Subject: Duke Energy Corporation
Oconee Nuclear Station - Units 1, 2, and 3
Docket Nos. 50-269, 50-270, and 50-287

Revisions to Topical Report DPC-NE-3003 In Support of
Steam Generator Replacement
Response to NRC Staff Request for Additional
Information

Duke Power Response To Request For Additional Information

DPC-NE-3003 Revision 1 “Mass and Energy Release and Containment Response Methodology”

GOTHIC 7.0 - FATHOMS COMPARISON
ROTSG STEAM LINE BREAK
(1.0 ft² Break with SG Level Controlled to 90")

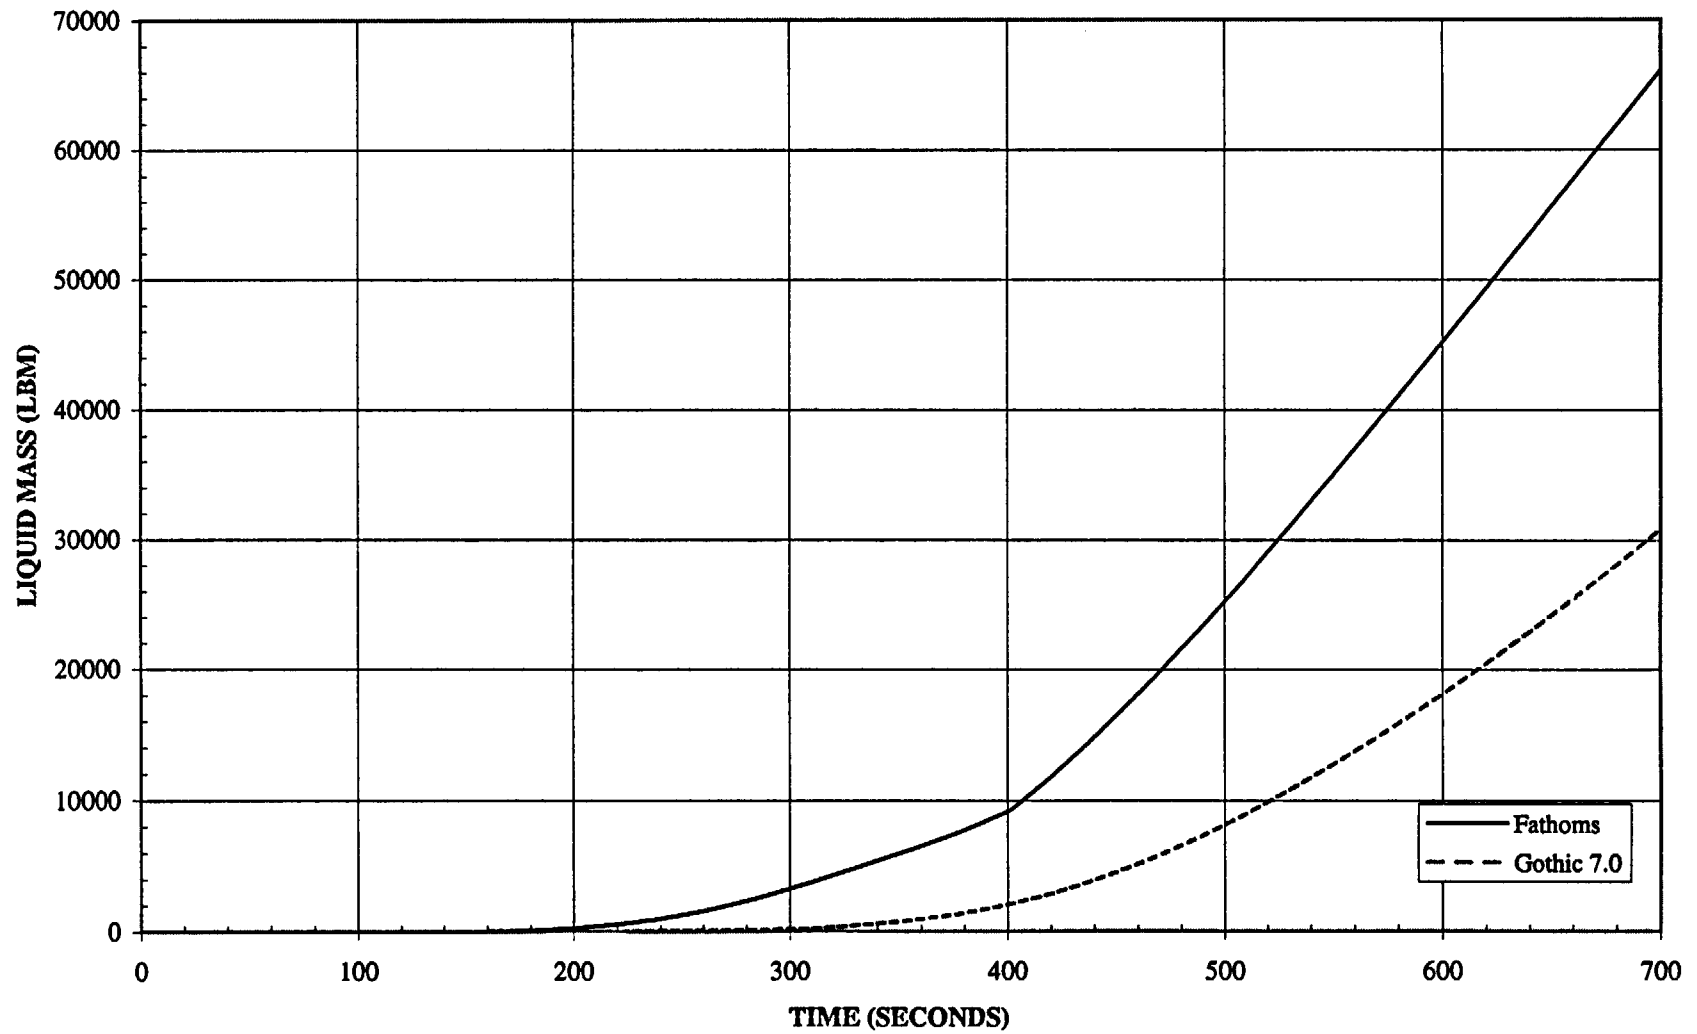
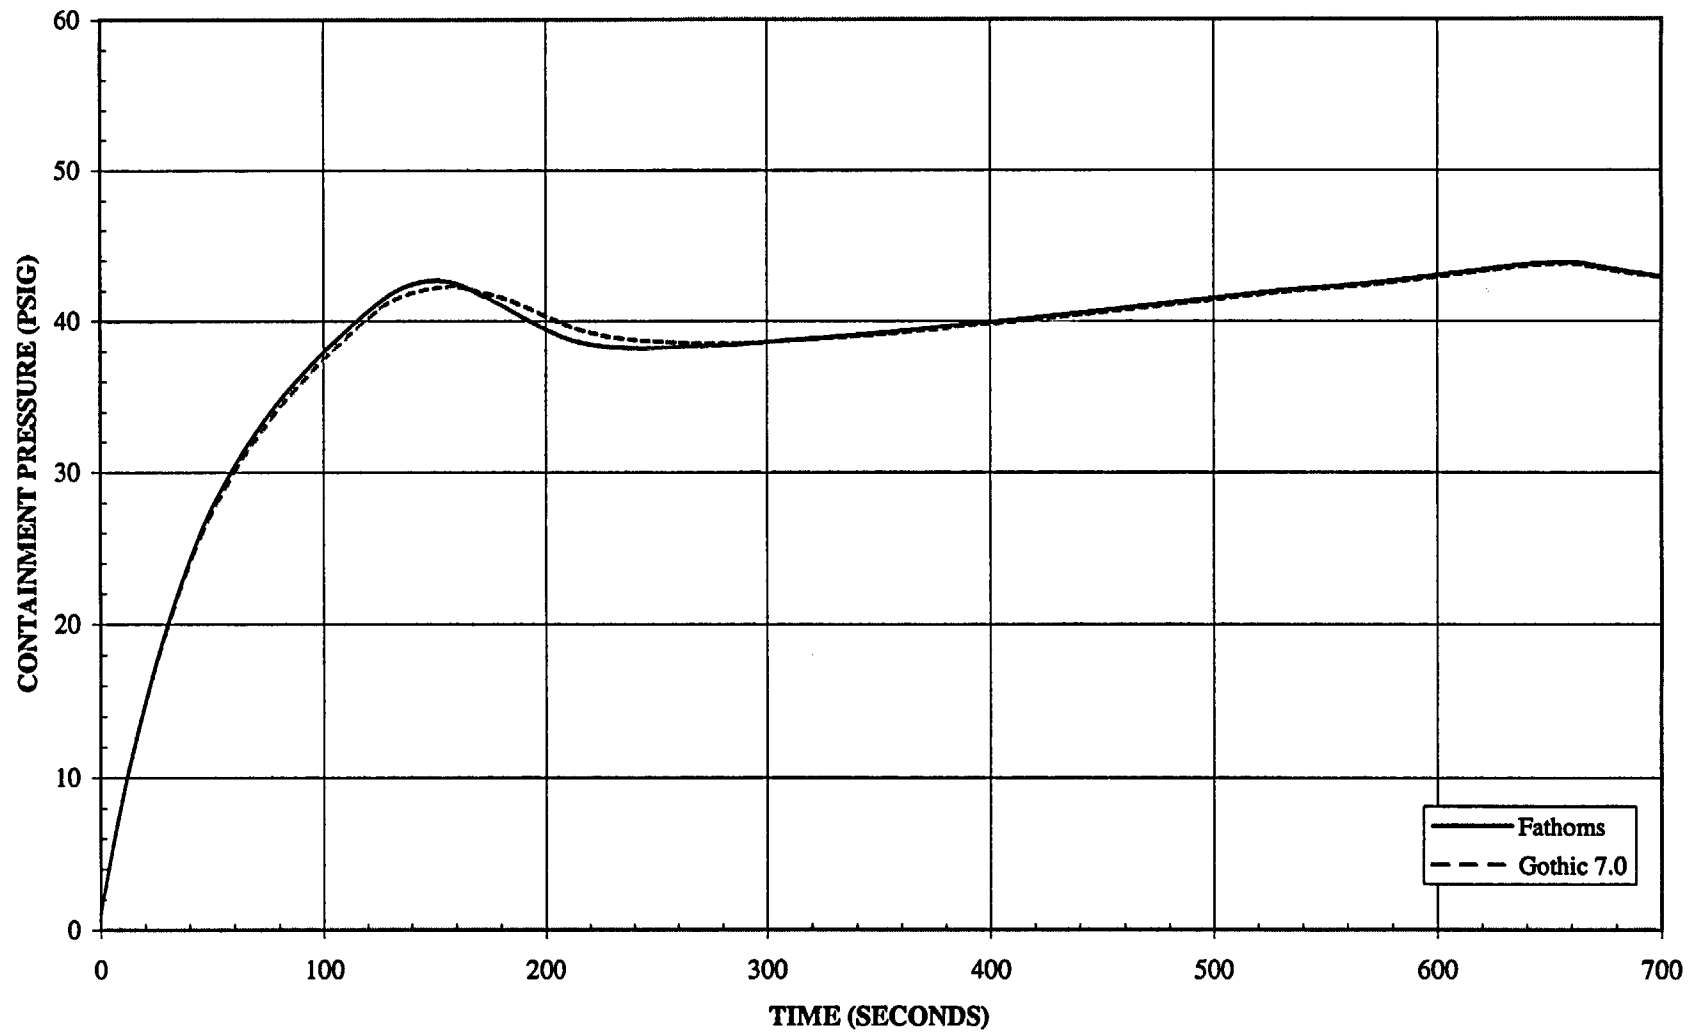
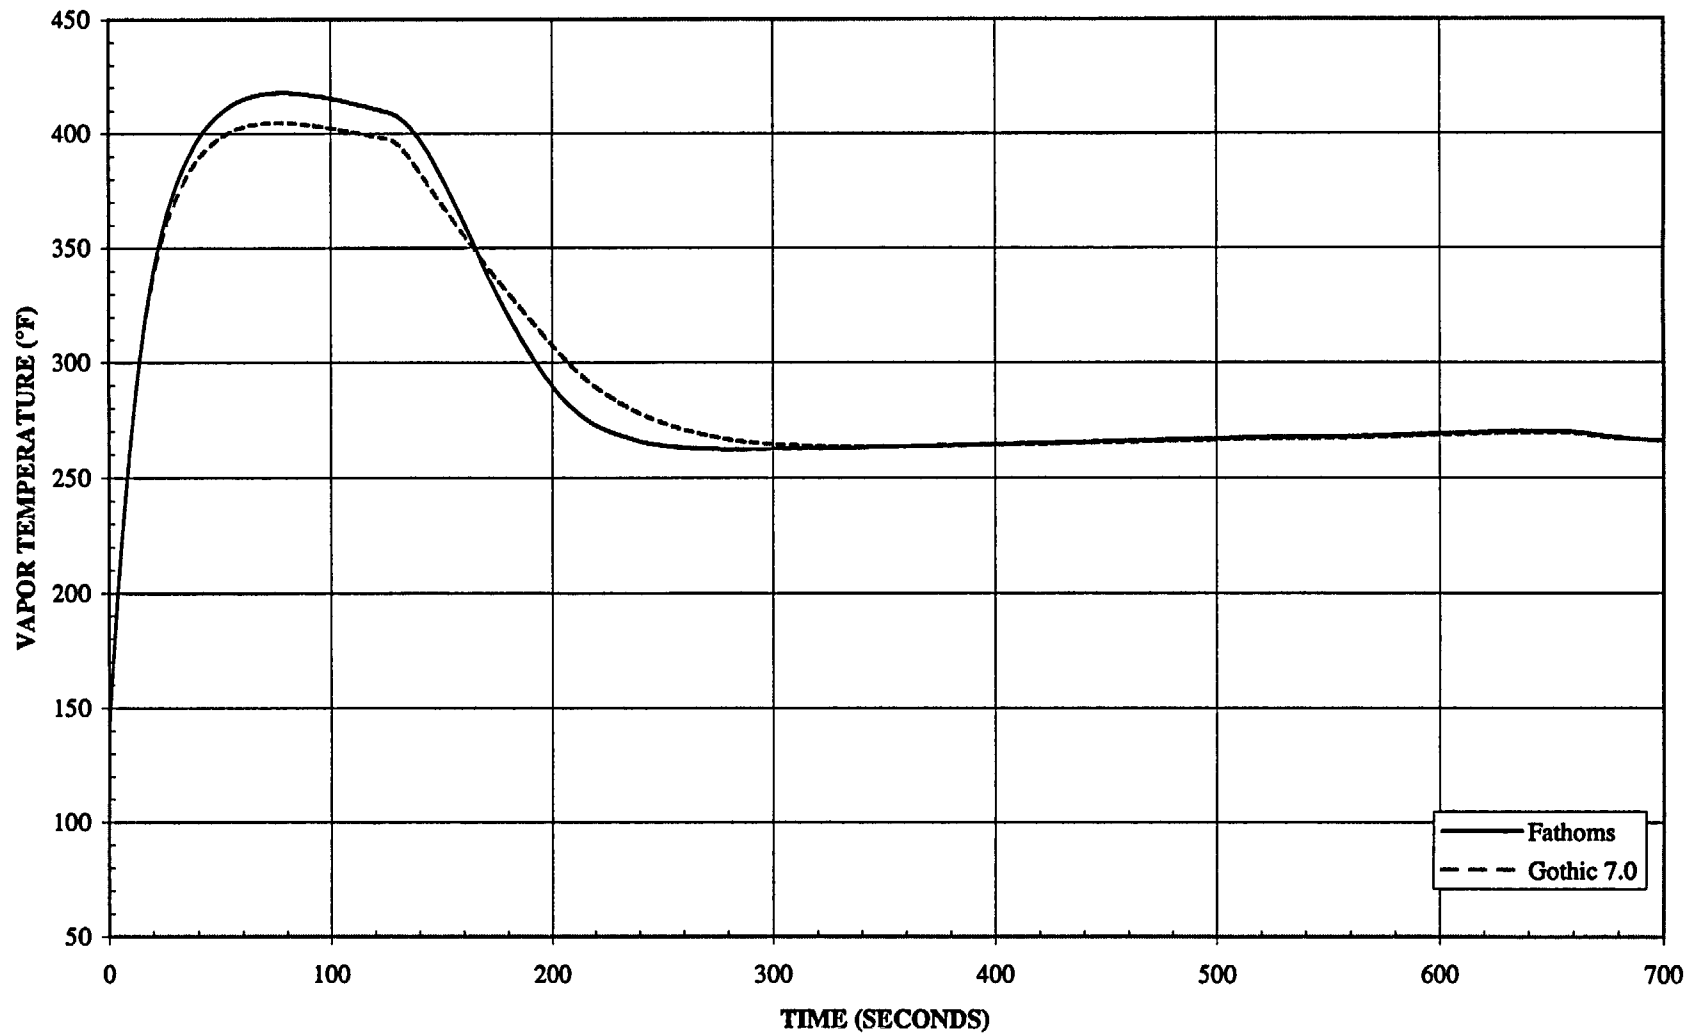
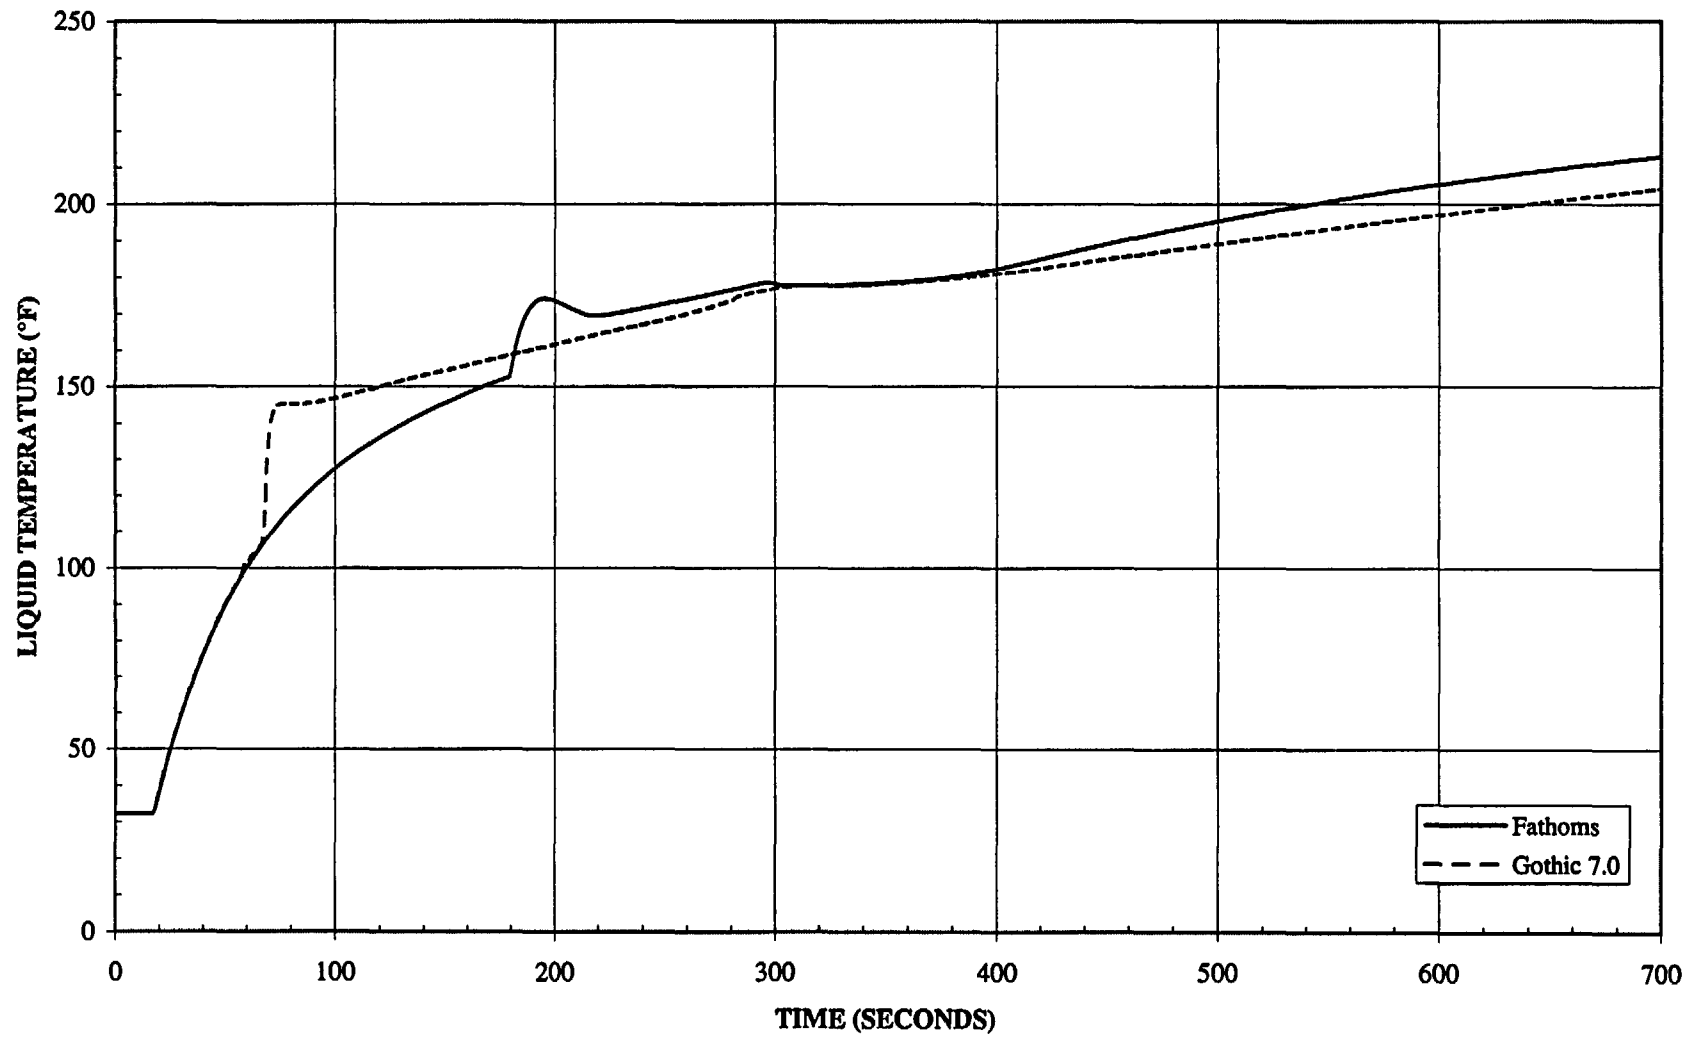
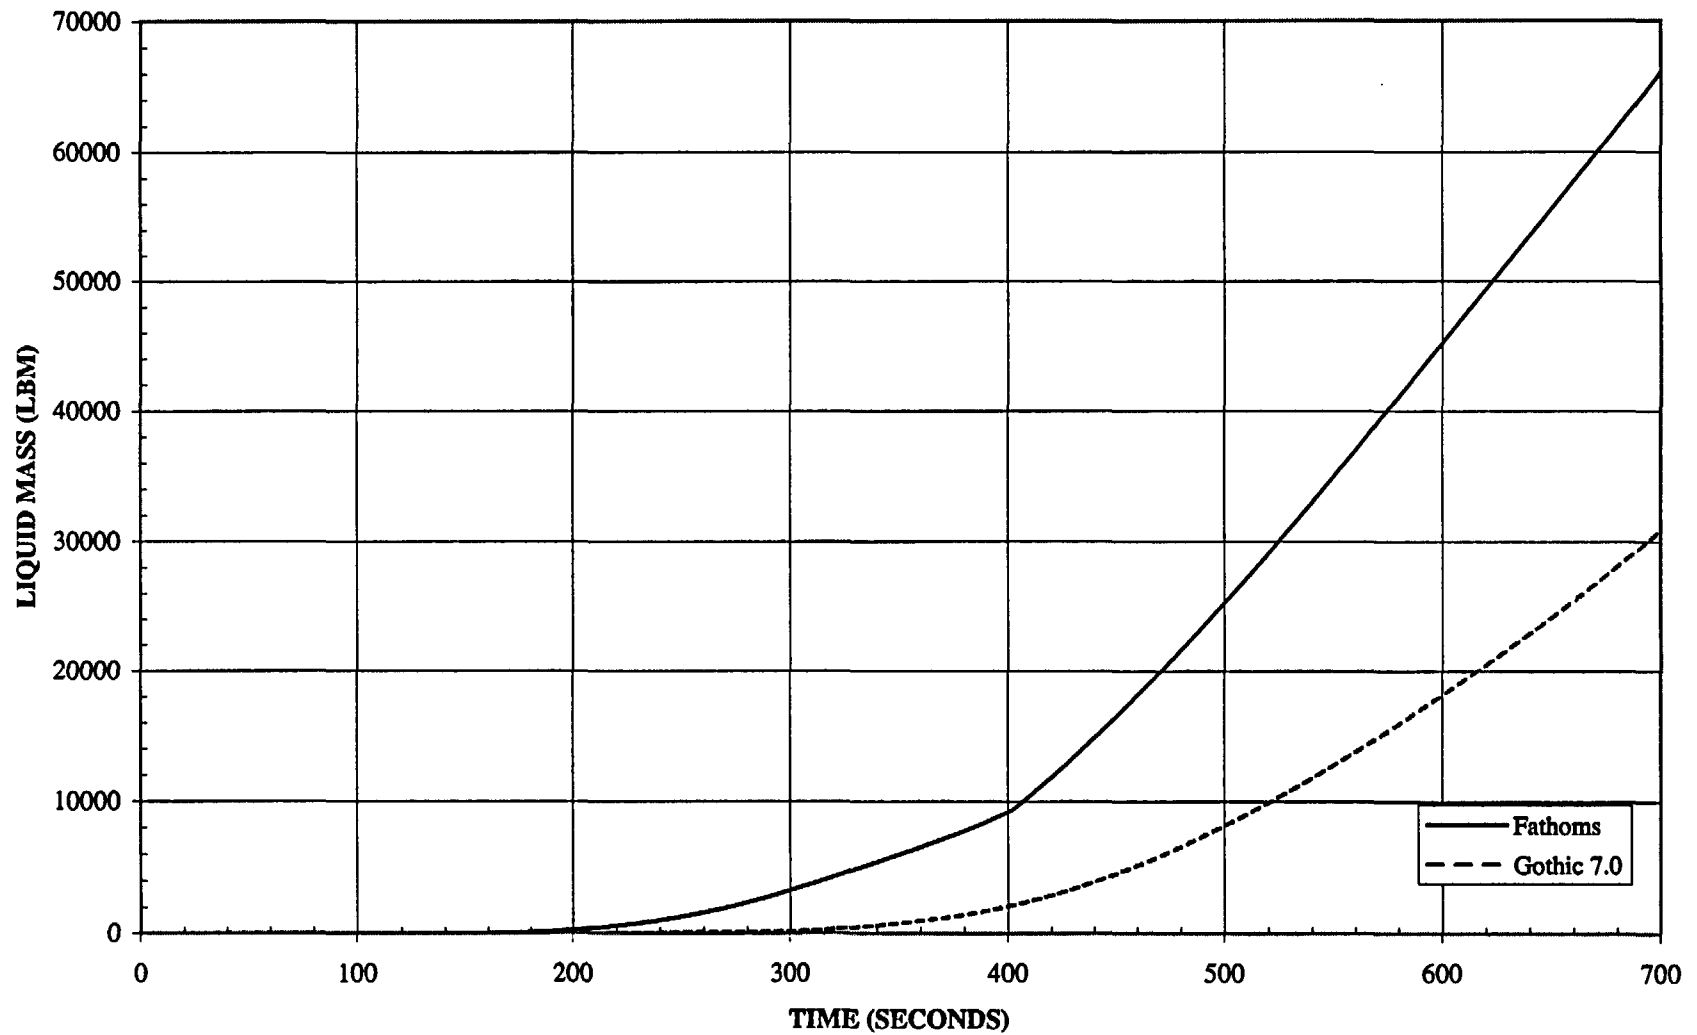
14. Show that GOTHIC and FATHOMS calculations result in the same pressures, temperatures, sump temperatures, etc. for the design basis LOCA and main steam line break events. If they do not, explain differences in terms of the differences in models between the two codes. (See Question 1.)

Response: Refer to the response to Question #3 for LOCA. The results of the 6 code comparison analyses for the main steam line break are given in Table 14-1 and the figures that follow. The containment response following a main steam line break event for the ROTSG was performed to compare the results from FATHOMS 2.4 and GOTHIC 7.0. In general, the pressure and vapor temperature responses are very similar. GOTHIC 7.0 predictions for peak pressures are slightly lower on the smaller break sizes (~0.3 psi) and slightly higher for larger break sizes (~0.95 psi). The peak vapor temperature responses predicted by GOTHIC 7.0 overall are slightly lower (~12°F). For larger break sizes, the higher pressure predicted by GOTHIC 7.0 may be attributed to additional steam generation from the improved interface heat and mass transfer models and from the drops that are generated due to dripping. The slightly lower pressure for smaller break sizes may be attributed to additional droplets in the atmosphere. The slightly lower vapor temperature and liquid temperature in GOTHIC 7.0 for all break sizes may be attributed to additional droplets in the atmosphere also. This effectively increases the heat capacity of the atmosphere and reduces the temperature rise for a given energy addition. As discussed in the responses to Questions #1 and #3, more liquid is predicted to remain in droplet form in GOTHIC 7.0 which results in less liquid mass in the sump. In addition, the lower sump temperature predicted by GOTHIC 7.0 may be attributed to the addition of the second energy equation for the drops and the improved heat and mass transfer models in GOTHIC 7.0.
